Construction Industry Coalition on Water Quality

May 14, 2012

RE: Proposed Amendments to Order No. 2009-0009-DWQ as Modified by DWQ [NPDES No. CAS000002] General Permit for Discharges of Storm Water Associated with Construction and Land Disturbance Activities (Construction General Permit).

Figure 1. Hourly pH in the Trinity River near Weitchpec. The station (WPC) is located at latitude 41.179 and longitude -123.706. pH data (N=11,864) are available only from 05/05/2005 to 10/04/2005. Source: <http://cdec.water.ca.gov>.

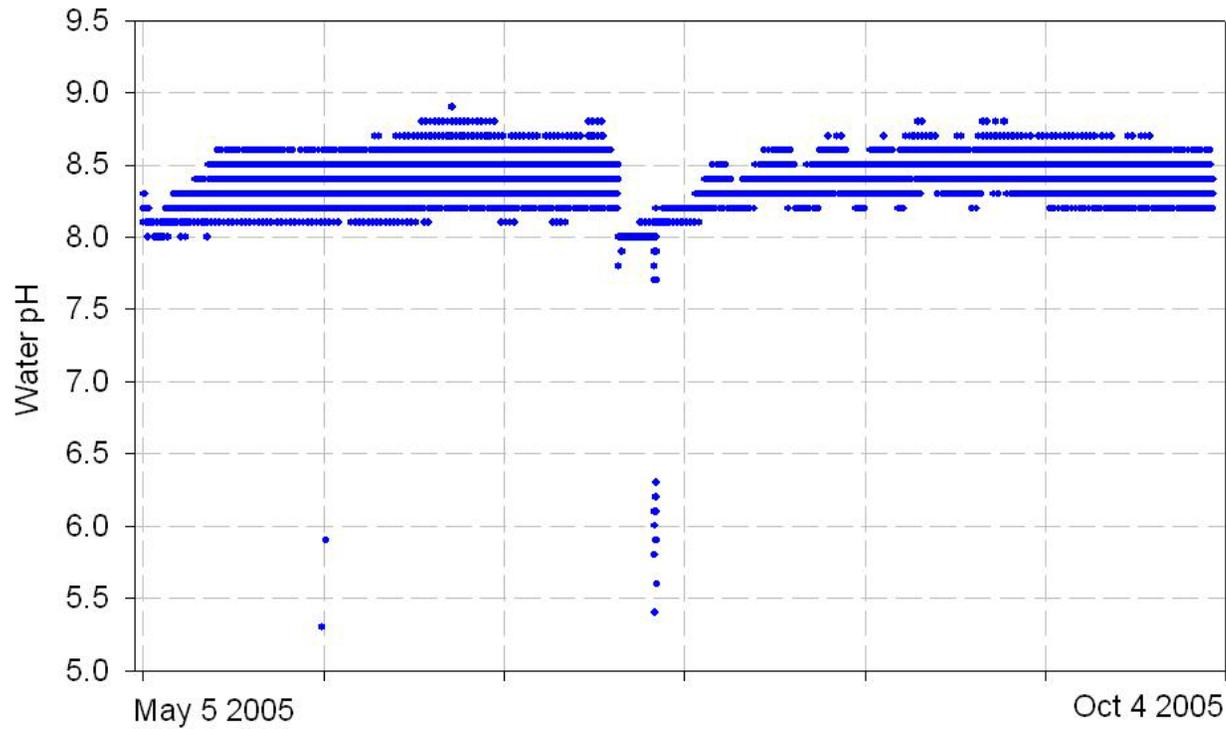
The numeric trigger was developed without consideration of receiving water quality

pH values outside the range of the numeric trigger occur naturally in some streams (see Section 4 of Flow Science (2008)). For example, some areas of California include alkaline soils, and pH in runoff from these soil types may be higher than average values. Background receiving water pH ranges as high as 8.9 in the Trinity River near Weitchpec (see Figure 1 and Section 4 and Table 18 at p. A-20 of Flow Science (2008)) and as high as 9.5 in San Diego Creek [see p. A-23, Flow Science (2008)]. Because of regional variations in natural or background pH levels, it is inappropriate to apply a uniform numeric trigger statewide. Where natural or background pH levels fall outside or at the margins of the numeric trigger range, the numeric trigger should not apply.

Figure 2. pH of precipitation for November 26 - December 23, 2001. Obtained from <http://water.usgs.gov/nwc/NWC/pH/html/ph.html>.

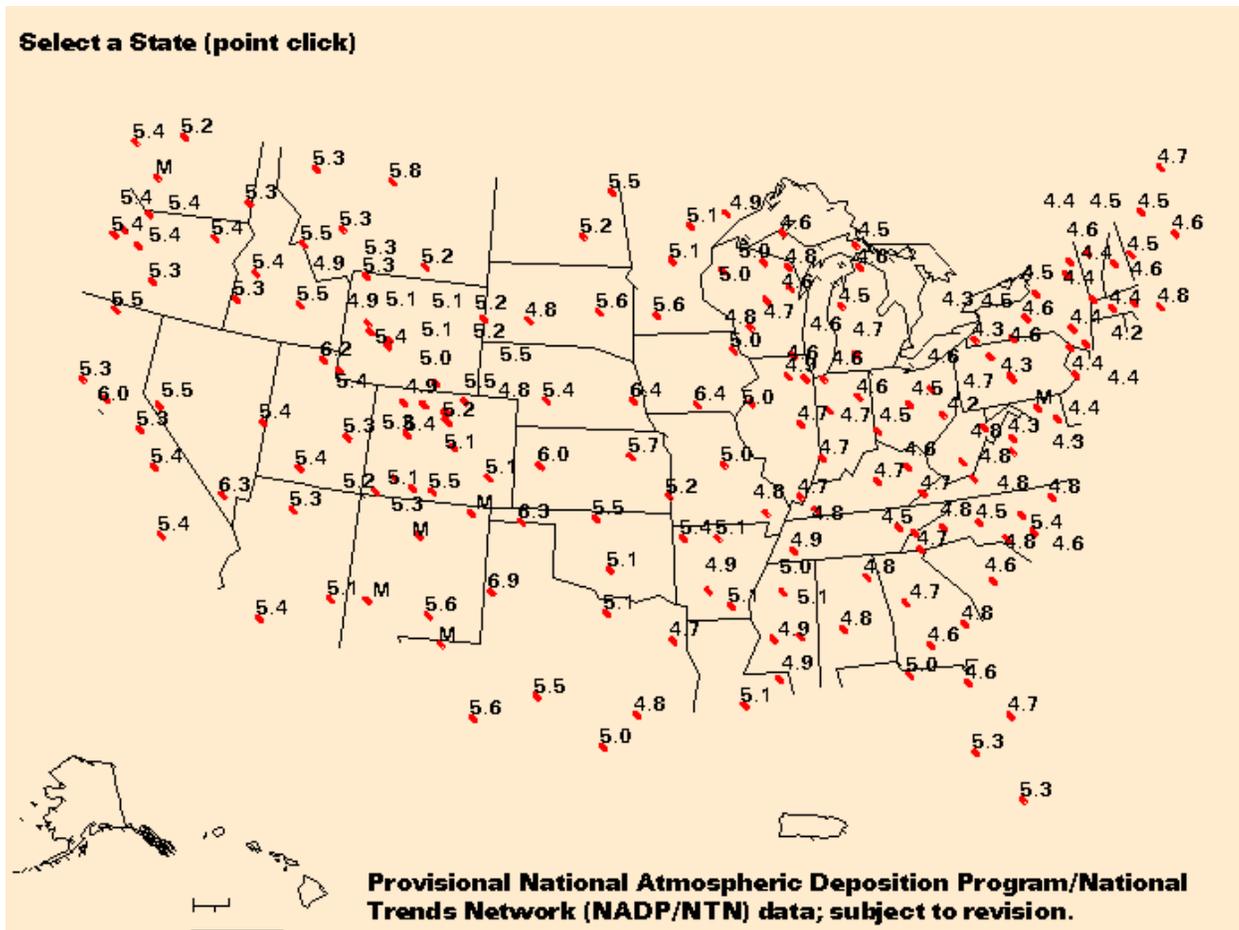
The pH of rainfall falls outside the numeric trigger range

Data collected by the U.S. Geological Survey (USGS) indicate that rain in California has a long-term average pH that varies between 5.3 and 6.0, depending upon location (Figure 2). For individual storms, pH values as low as 4.5 have been observed (see, e.g., <http://nadp.sws.uiuc.edu/ads/2003/CA45.pdf>). If storm water runoff includes water that has not had significant contact time with soil or earth, it is possible for runoff pH values to be low and outside the range of the numeric trigger. Samples with a pH value below 6.0 (i.e., below the numeric trigger) should not be considered to trigger the receiving water monitoring if insufficient contact time with the ground surface is the cause of the exceedance.

Figure 3. EPA level III ecoregion map with median suspended sediment concentrations (mg/l) for ecoregions 6 and 14 from Simon et al. (2004).

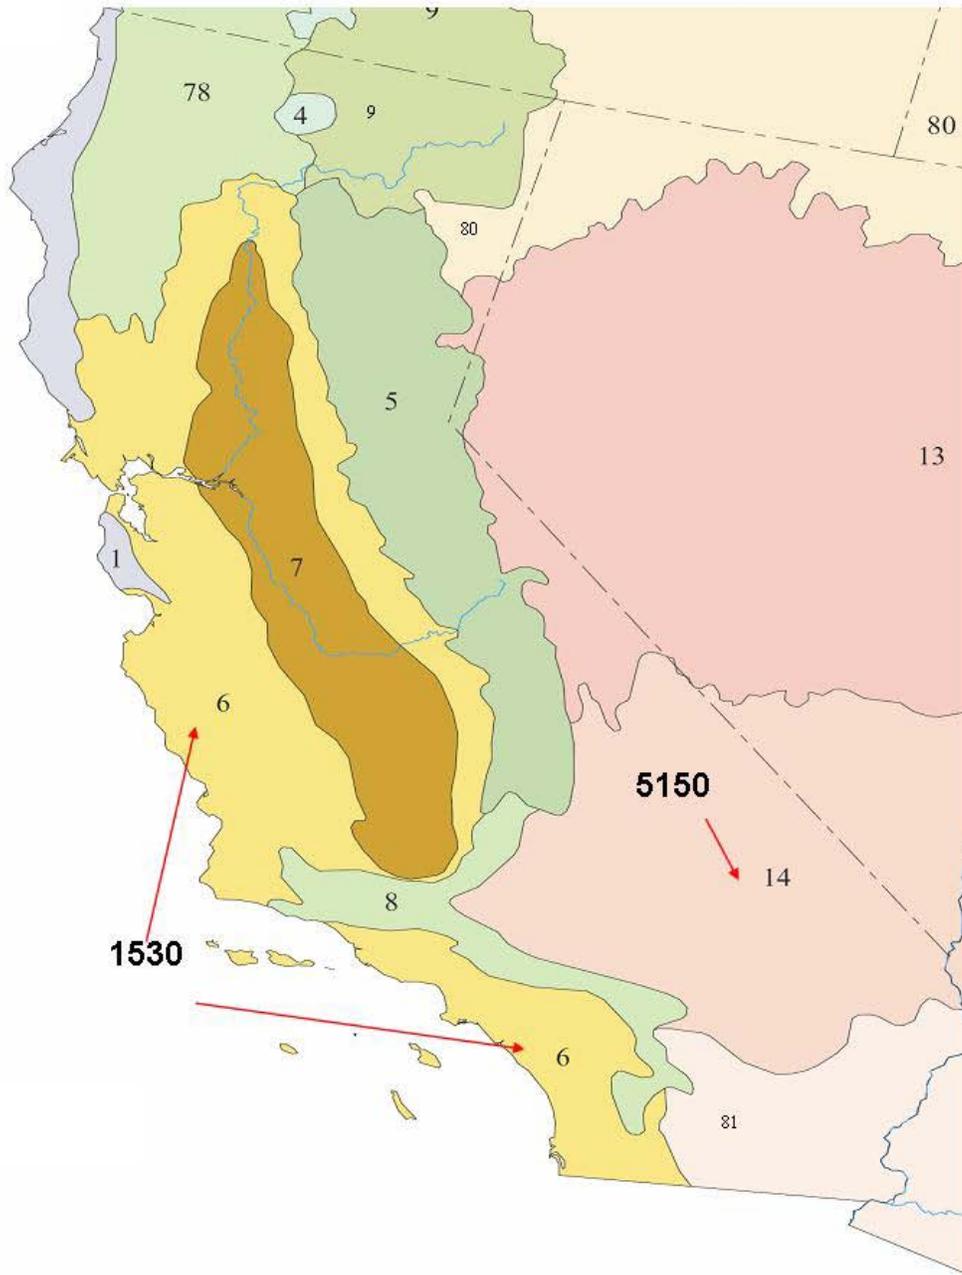
The eco-region data used to develop the numeric trigger for turbidity are limited and not suitable to describe stormwater quality from a construction site

Simon et al. (2004) estimated suspended sediment concentrations (SSC) that were median values for 1.5-year flow events; these data were provided “*for the purpose of defining long-term transport conditions*” of sediment. The Simon et al. (2004) dataset did not characterize event-scale variability, even though data for individual storms would be used to assess exceedances of the proposed numeric trigger. Even using staff’s estimate of 1:3 ratio for turbidity:SSC (which is faulty, as described below), more than 50% of the data in more than 40% of the State would greatly exceed the numeric trigger of 500 NTU. For example, *median* values of SSC in ecoregions 6 and 14 for a 1.5-year flow event are 1530 and 5150 mg/l, respectively (Figure 3). The state-wide “area-weighted average” median SSC concentration provided in the Fact Sheet (p. 16) is 1633 mg/l, far higher than the proposed numeric trigger of 500 NTU, and appears to indicate that at least 50% of samples from across the state would exceed the numeric trigger. In addition, the ecoregion data clearly indicate that some regions of the state experience greater erosion than others. For example, the median SSC concentration from ecoregion 5 (8.8% of California’s land area) is 35.6 mg/l, while the median SSC concentration from ecoregion 14 (21.7% of the state’s land area) is 5150 mg/l. These data indicate that a blanket, “one-size-fits-all” numeric trigger is inappropriate for the state.

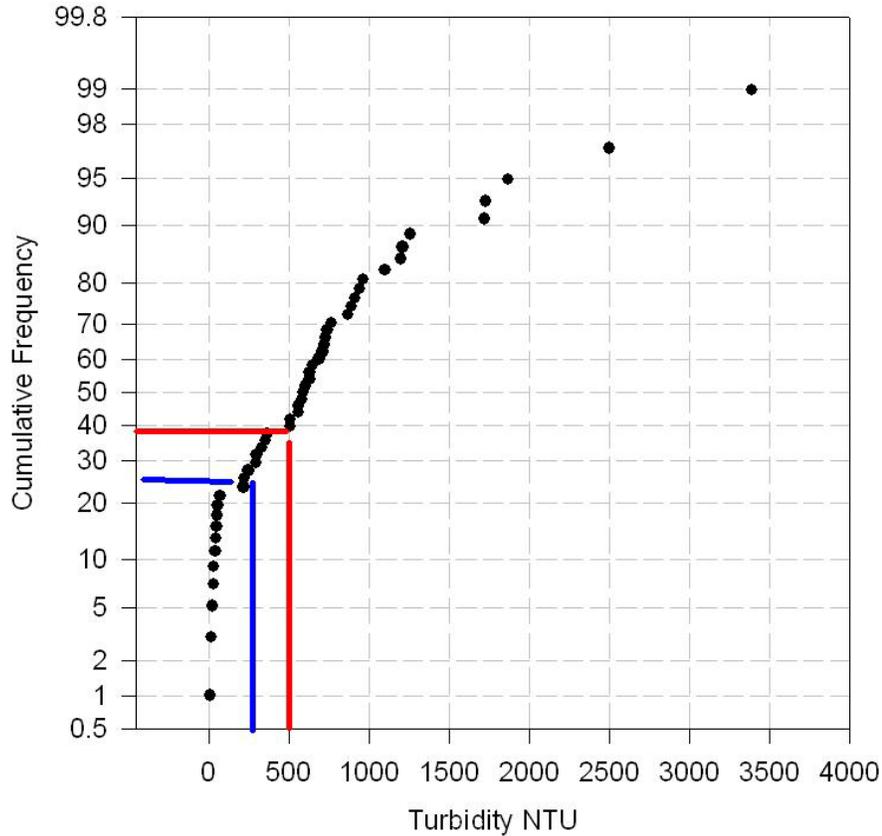
Numerous studies demonstrate that turbidity in receiving water often exceeds the numeric trigger of 500 NTU

- Caltrans monitoring data for turbidity show that “typical construction site runoff” in California ranges from 15 NTU to 16,000 NTU (Caltrans 2002). Available Caltrans data from 1999-2002 show that 60% of Caltrans data exceeded the numeric trigger of 500 NTU (Figure 4). These data indicate that the numeric trigger of 500 NTU does not represent an “*upset value, which is clearly above the normal observed variability,*” as recommended by the Blue Ribbon Panel (p. 17 of Blue Ribbon Report, emphasis added).
